MULLET CREEK BRIDGE  
GENERAL LAYOUT

# FOUNDATION INVESTIGATION REPORT

Proposed Structure Over Relocated  
Mullet Creek and New Hwy. 403  
Site 24-386, W.P. 157-75-05  
District 6, Toronto

RE: Mullet Creek Bridge  
W.P. 157-75-05, Site 24-386  
Hwy. 403, District 6, Toronto  
Contract 80-71

PLAN  
SCALE:  $1" = 20'-0"$

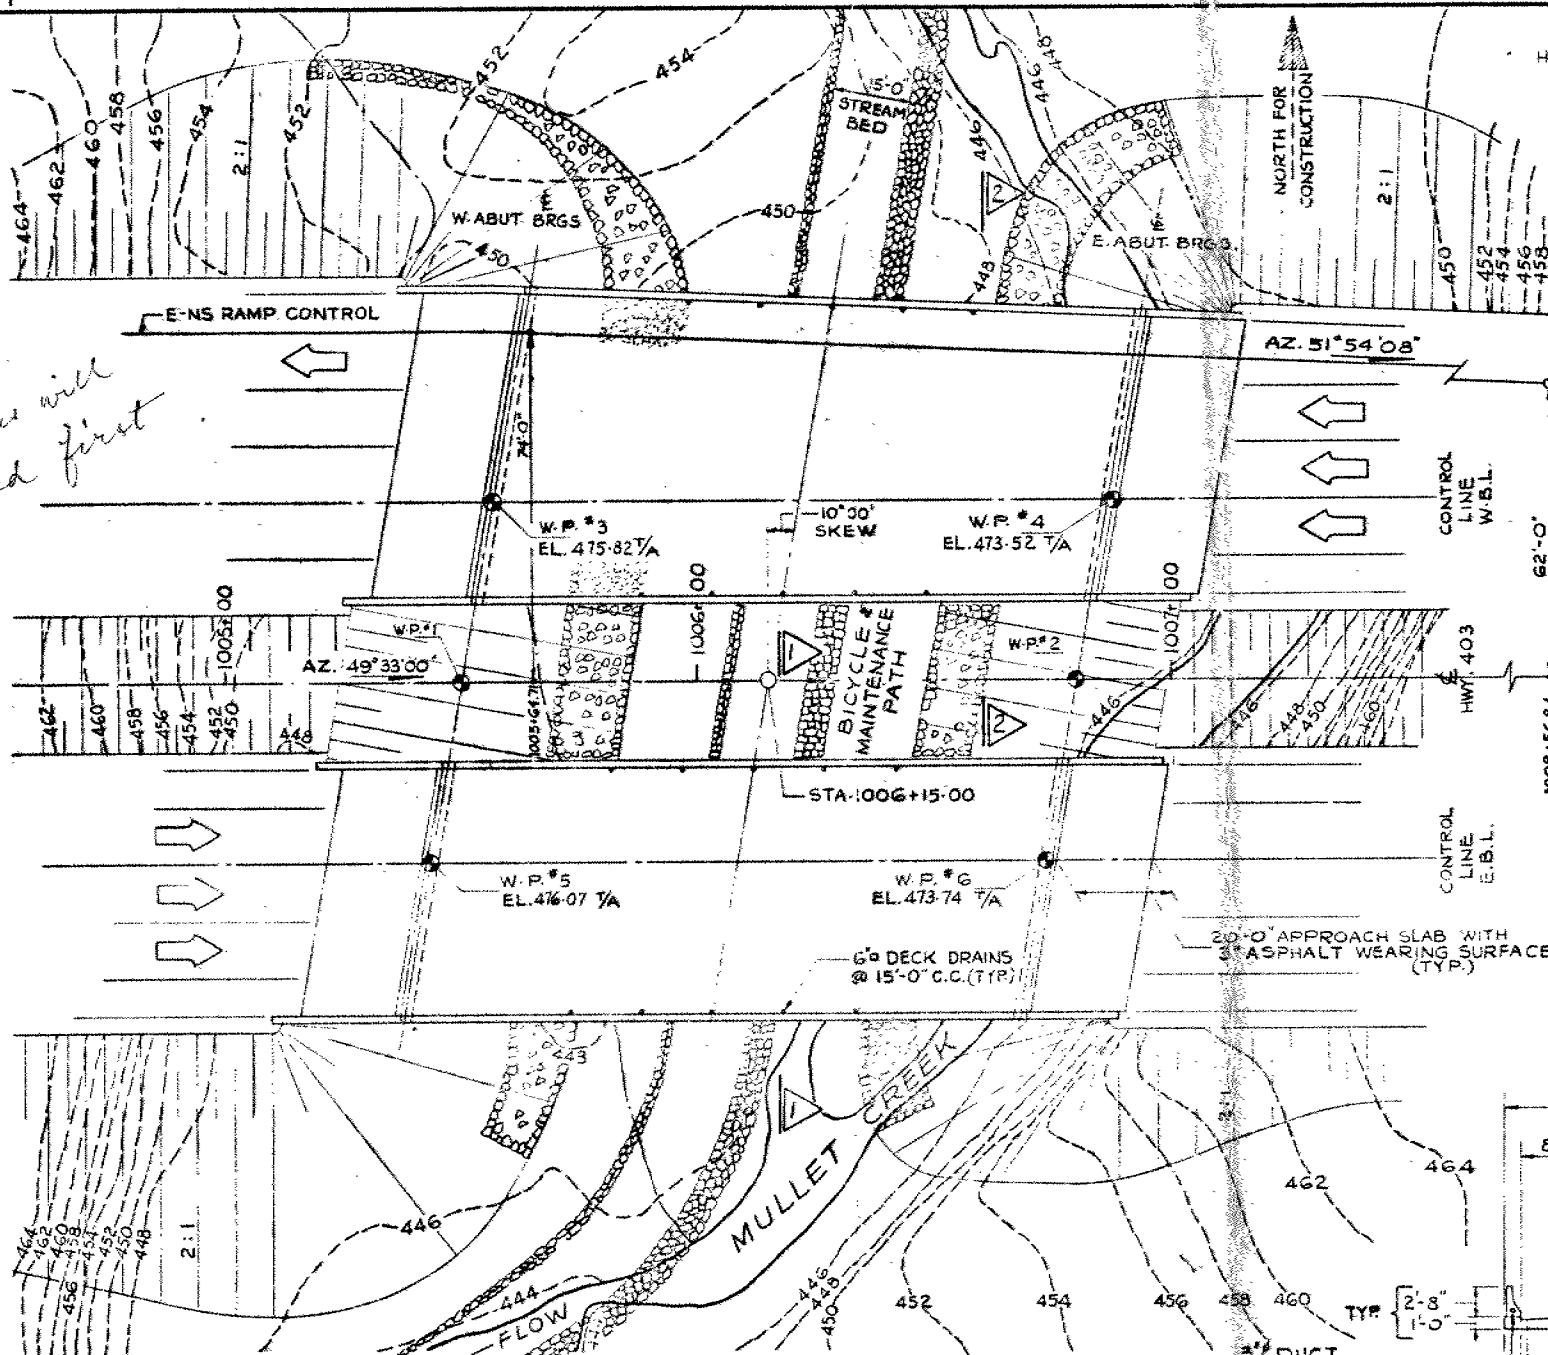
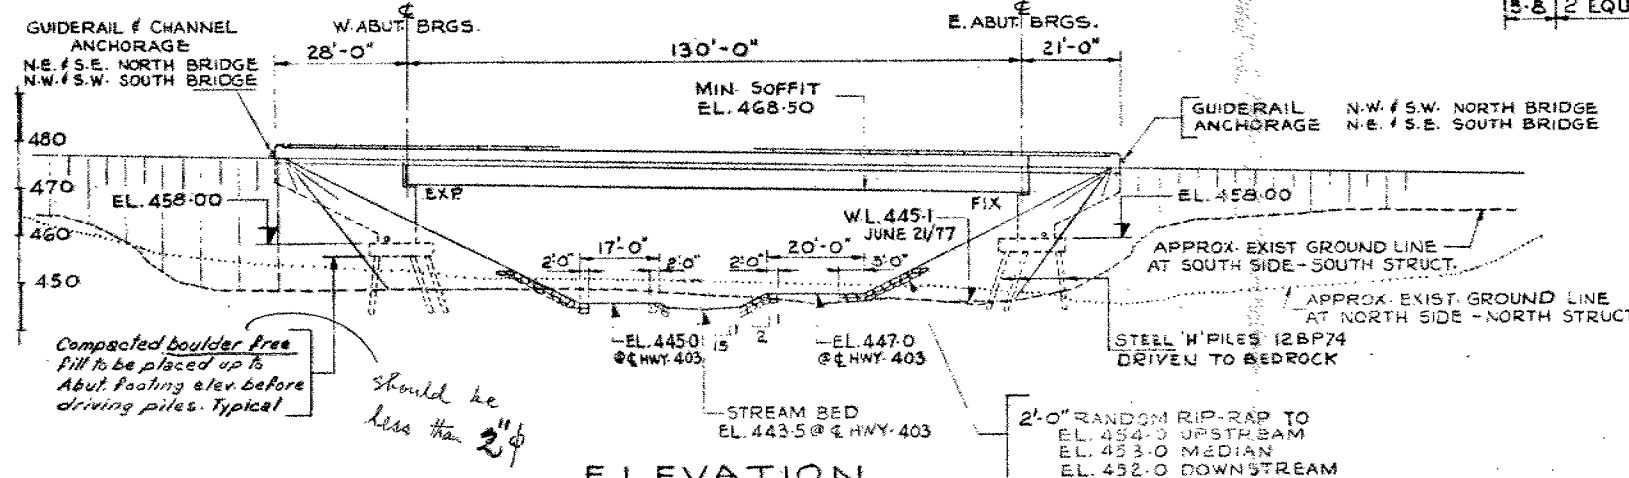
oil pipelines will  
be relocated first
